REPORT TO DESIGN COMMISSION City of Sacramento

PUBLIC HEARING
May 19, 2010

Subject: **625 H Street (DR10-033)** Located at the northwest corner of 7th and H Streets, a request to develop an eight story mid-rise 150 unit residential tower including 2,800+/- s.f. ground floor retail and 6,000 s.f. health clinic on 0.55+/- acres in the Central Business District Special Planning District (C-3-SPD) zone.

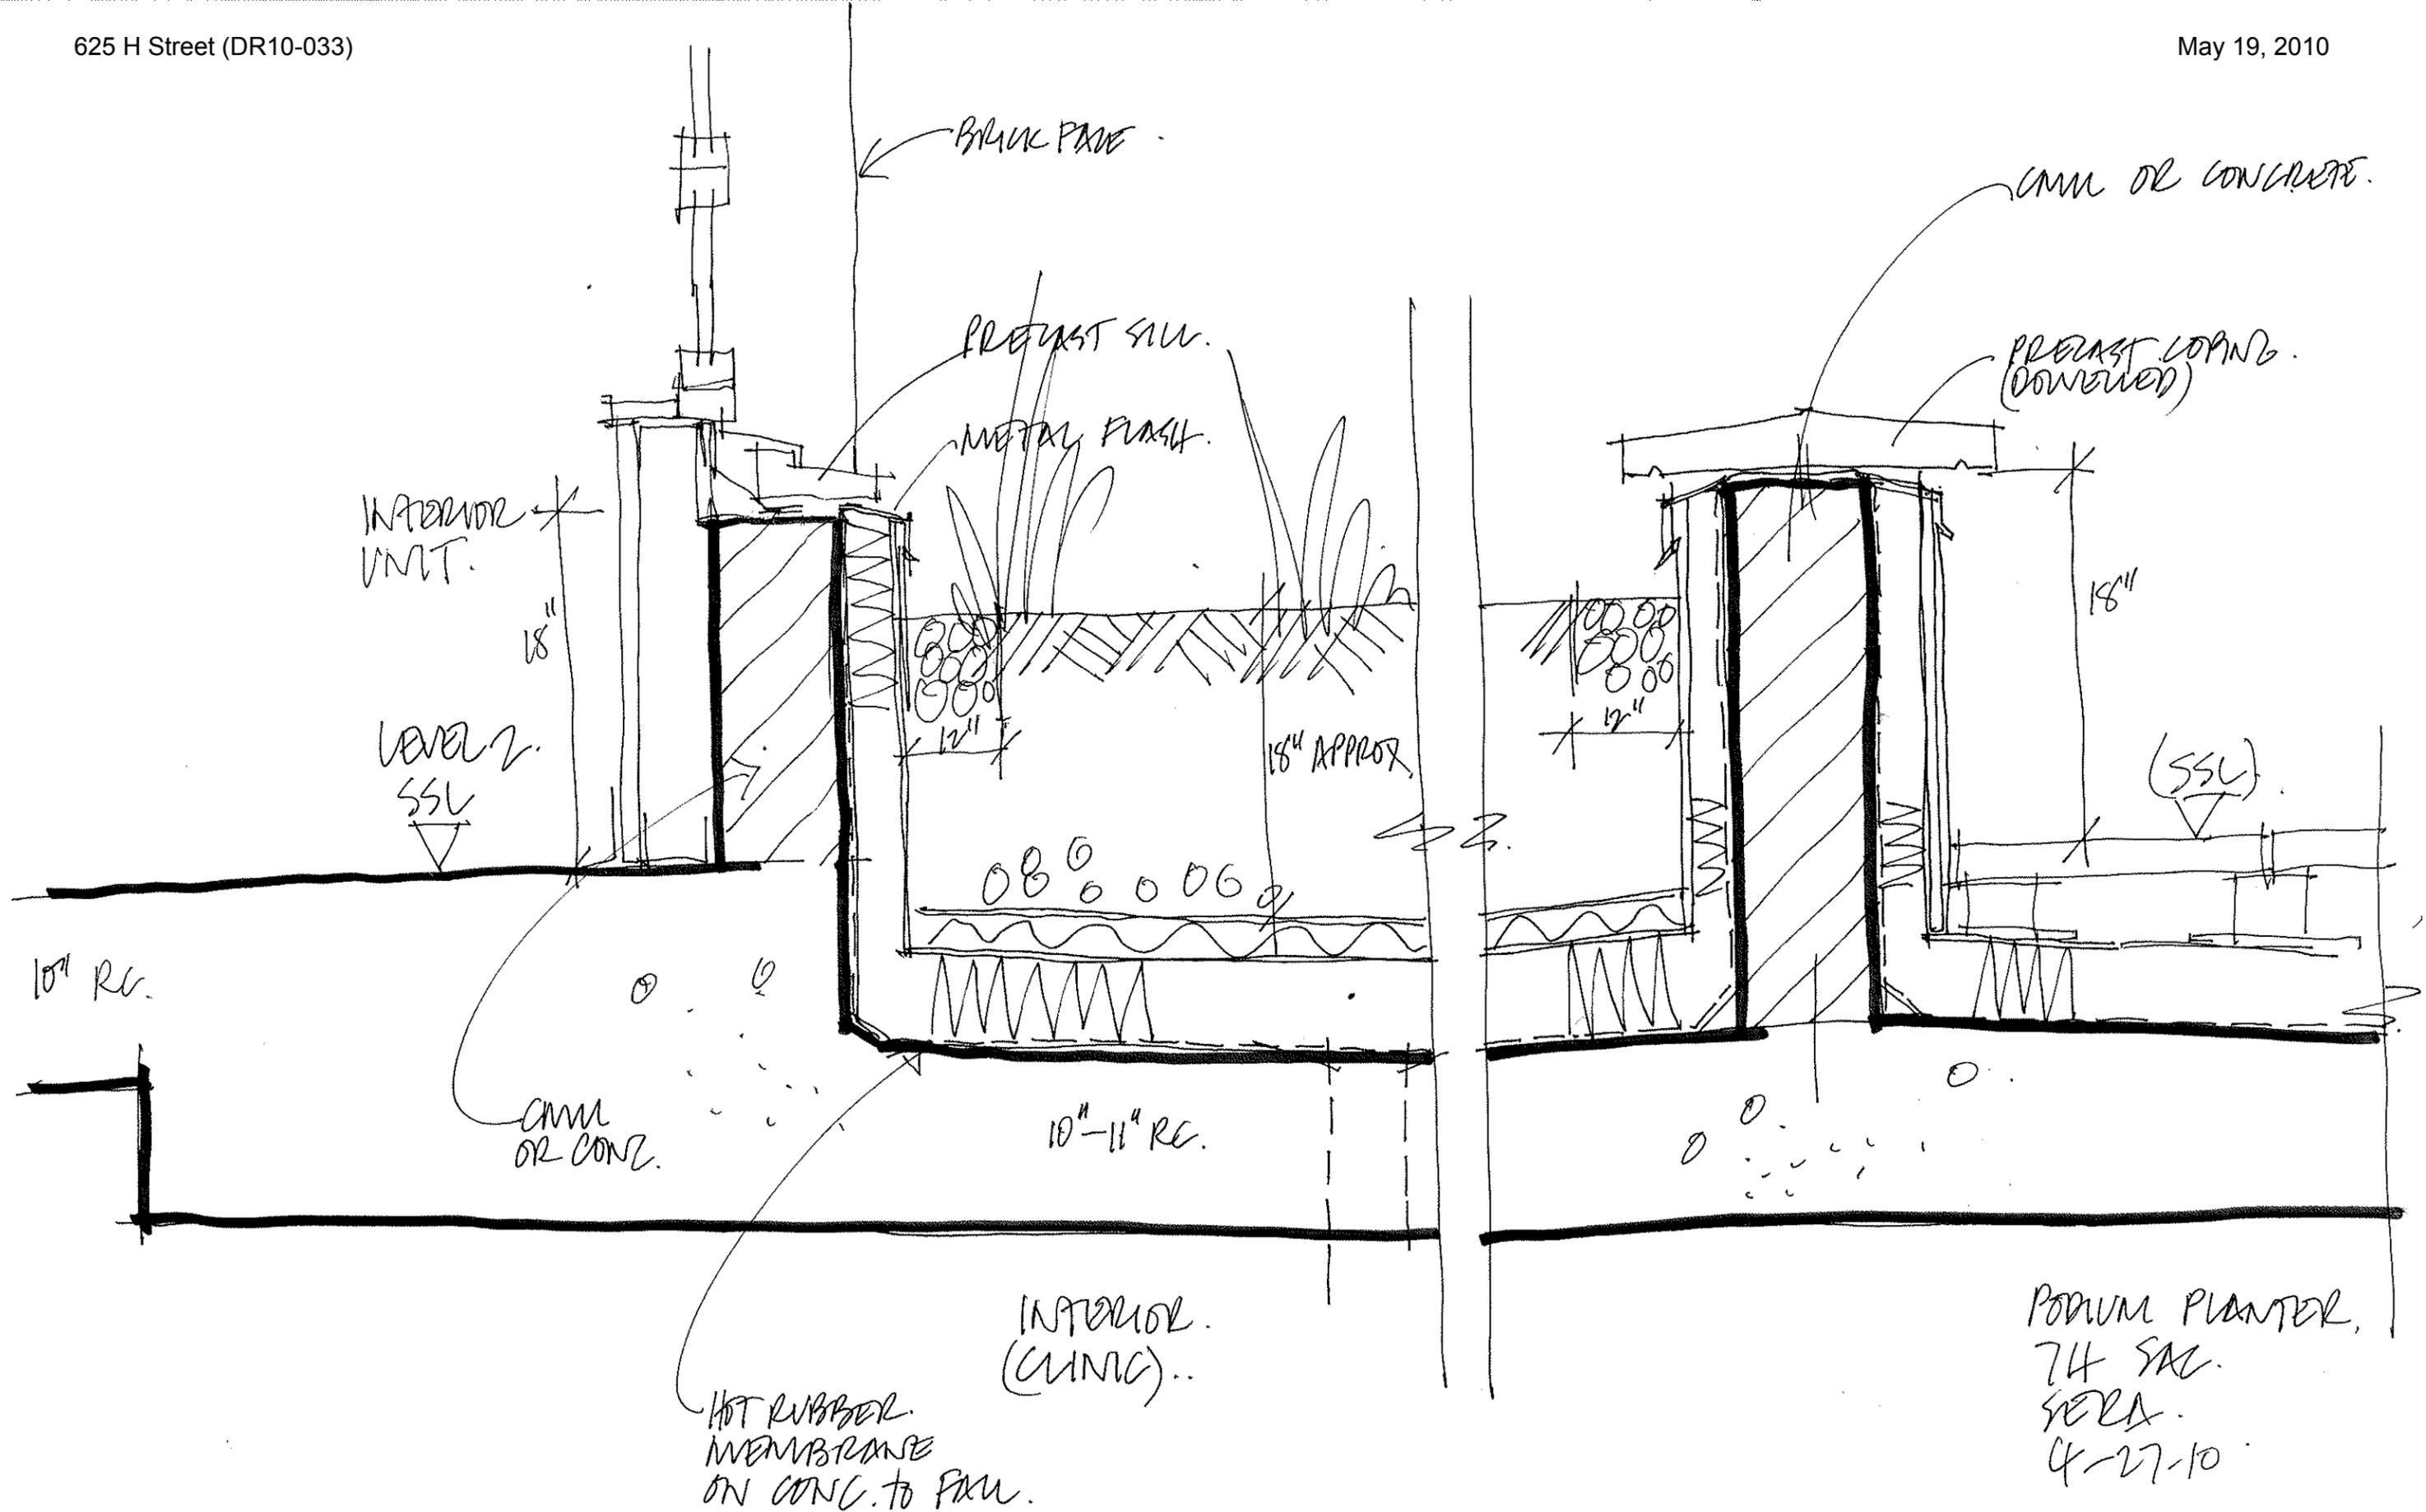
5. West elevation needs additional articulation as it is a very public side.
6. Proposed color palette is acceptable considering the quality and use of materials provided.

- b. A wedge-shaped pop-out punctuates the top two floors of the building creating the sense of that the “horizontal weave” brick pattern is peeling back from the building. This creates a triangular shadow on the west elevation, shades some of the windows below, and sets the building into a horizontal motion, giving it drama.

- c. The metal panel element at the inside corner has also be raised up above the parapet with extended walls back into the roof to break the cornice and make it more interesting. The metal extends back into the room to give the illusion that it is a metal tower emerging from the room. This will be most visible in a revised sketch perspective of the west wall –to be presented in the 5/19 hearing.

- e. In addition, we noticed that the tree canopy was not rendered high enough on the west elevation, showing the trees (on top of a 3’-6” tall planter) to be only 8 or 9 feet tall. Realistically, we should expect a canopy at about 18’ above the terrace so this has been changed in the elevation.

PODIUM PLANTER,
 74 SAC.
 SERA.
 4-27-10

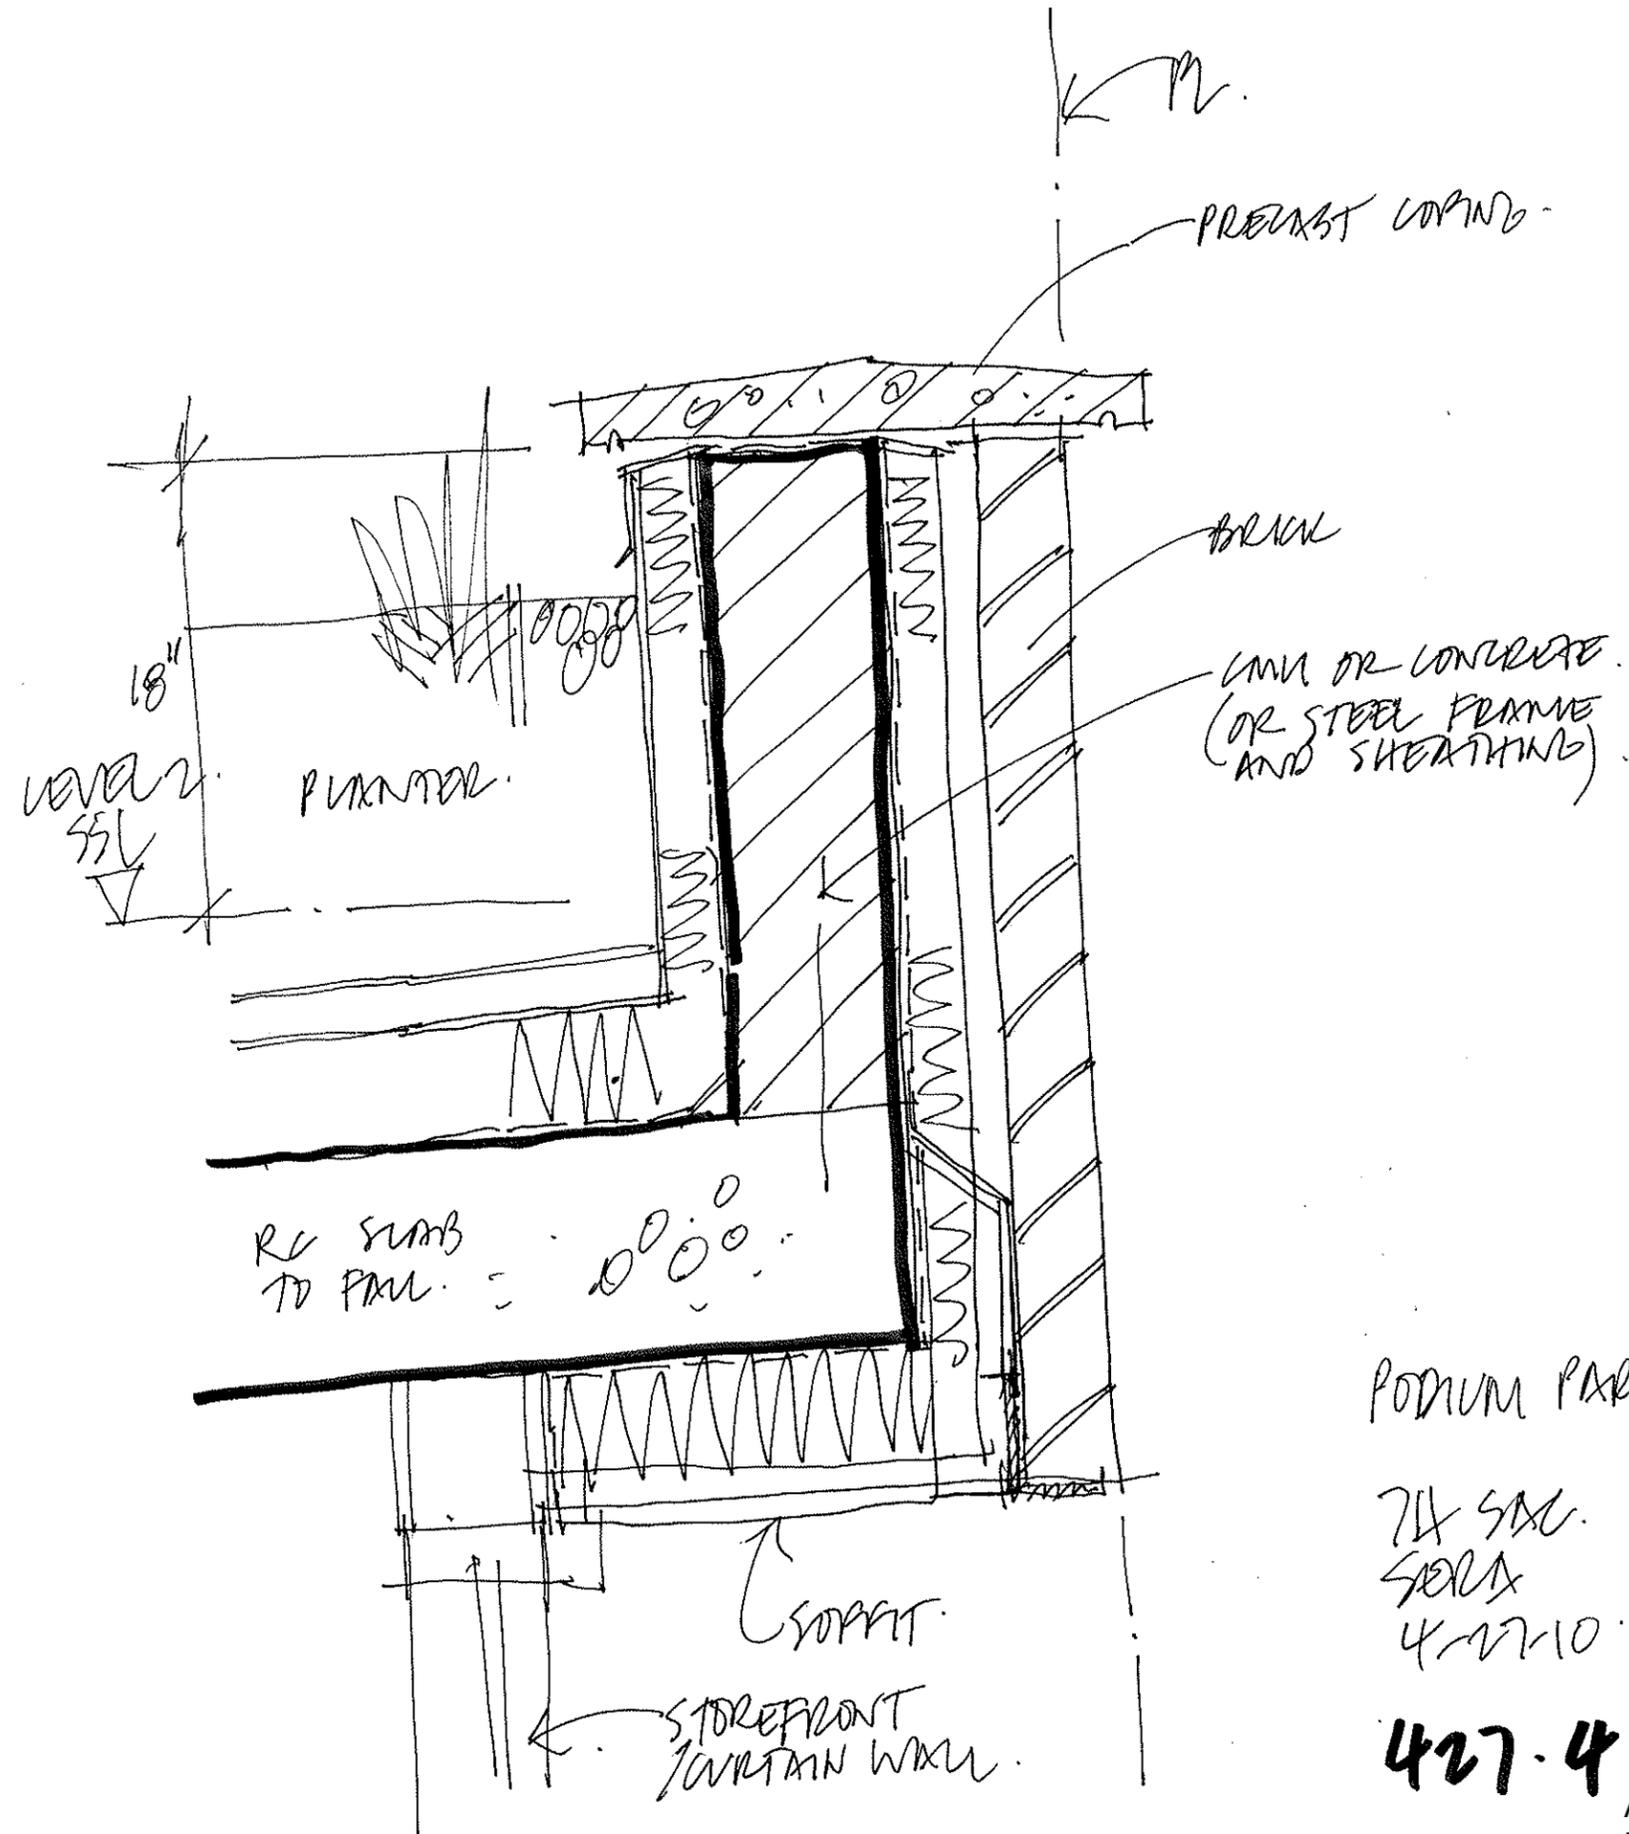
1. Plantings that are proposed at the terrace level seem better suited for wetter climates. The solar reflection of the building may impact these plantings and the amount of water that is required to support them. Please coordinate these comments on the plantings with the landscape architect prior to the next submittal. Also please confirm that there is enough soil volume for the green screen plantings.

- c. The typical planters on the terrace will have at least 18" depth. **See sketches in attached exhibit DR2-1.** The tree planters on the terrace will be detailed in a similar way but with a soil depth of 3'-6".
